**BEFORE INDEPENDENT HEARING COMMISSIONERS APPOINTED BY THE  
WAIMAKARIRI DISTRICT COUNCIL**

Hearing of Submissions and Further  
Submissions on the Proposed Waimakariri  
District Plan (**PWDP** or **the Proposed Plan**)

**SUPPLEMENTARY EVIDENCE OF MATHEW ROSS COLLINS  
IN RESPONSE TO OFFICER REPORT  
ON BEHALF OF BELLGROVE RANGIORA LIMITED  
REGARDING HEARING STREAM 12E**

DATED: 2 August 2024

Figure 1: Revised ODP, with changes to Northbrook Road clouded

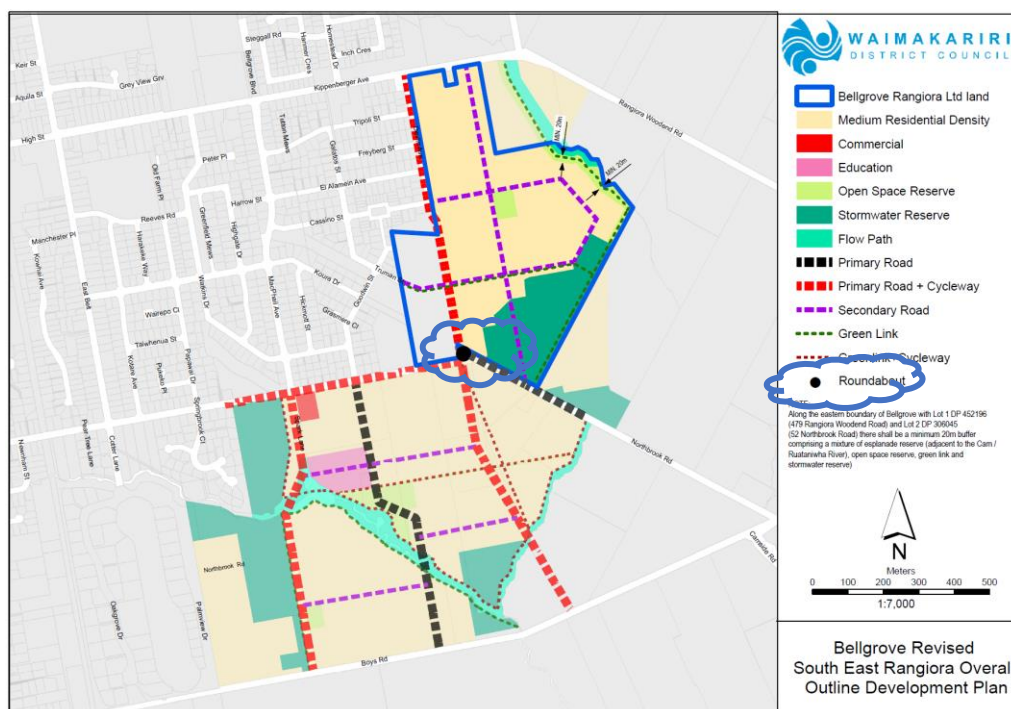
- 22 The Officer Report expresses concern about driver sightlines at the proposed Devlin Avenue / Boys Road / Northbrook Road intersection and recommends Supplementary evidence of Mathew Collins in response to Officer Report on behalf of Bellgrove dated 2 August July 2024

that a roundabout be considered, however it acknowledges that the Bellgrove SER-ODP is consistent with the notified ODP (paragraph 565, bullet point 4).

23 I agree with Council's transport expert that the Devlin Avenue / Boys Road / Northbrook Road interaction would likely create safety issues if it was formed as a priority-controlled crossroad, due to higher vehicle volumes, higher vehicle speeds, and interrupted sight lines for Northbrook Road.

24 Figure 1 demonstrates how the updated SER-ODP put forward by BRL (at Attachment 2) could be updated to readily incorporate Council's transport expert advice by:

- (a) Showing a roundabout at the Devlin Avenue / Boys Road / Northbrook Road intersection; and
- (b) Extending the "Primary Road" typology between the Devlin Avenue / Boys Road / Northbrook Road intersection and the Northbrook Road/Secondary Road intersection to the east.

25 However, I consider that the exact nature of this intersection and its relationship with Northbrook Road is best addressed at the time of subdivision.

Figure 5: Bellgrove Updated SER-ODP (amended for Supplementary Evidence)

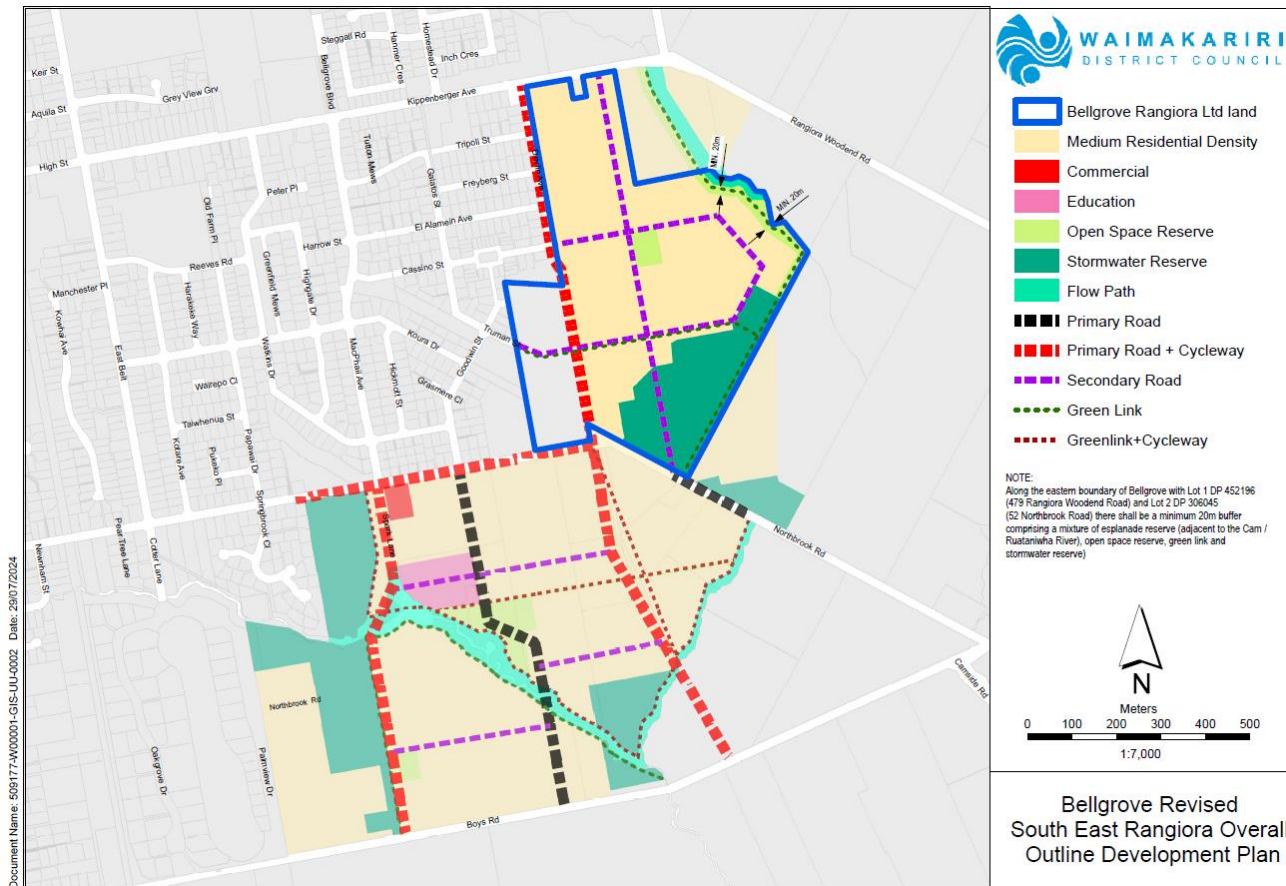
- 15 The Officer Report expresses concern about 4-way intersections shown on the BRL SER-ODP, including the intersection of Devlin Avenue and Cassino Street (paragraph 565, bullet point 2).

- 16 The notified ODP also included a 4-way intersection at Devlin Avenue and Cassino Street, and other intersections within the SER DA. The BRL SER-ODP is consistent with this.

- 17 I agree with Council's transport expert that 4-way intersections can increase safety risks at higher volume and/or higher speed locations, however there are engineering solutions to address this if it is identified as an issue. In urban settings, potential mitigations include raised platforms or mini roundabouts.

- 18 I note that 4-way intersections are common within recent urban development to the west of the SER DA. For example, MacPhail Avenue has three 4-way intersections along its 800m length between Kippenberger Avenue and Northbrook Road. These intersections have been constructed without the Council requiring specific engineering solutions to mitigate the concerns raised in the Officer Report.

- 19 I consider that the BRL SER-ODP is appropriate. Any potential safety concerns associated with any 4-way intersections proposed can, if needed, be addressed through the future subdivision consent process. It is at this stage that Council will also typically require a Road Safety Audit be undertaken.

41 Bellgrove has provided an updated SER-ODP for the SER DA. I support the updated SER-ODP and consider that it will provide for a safe, efficient, and connected transport network.
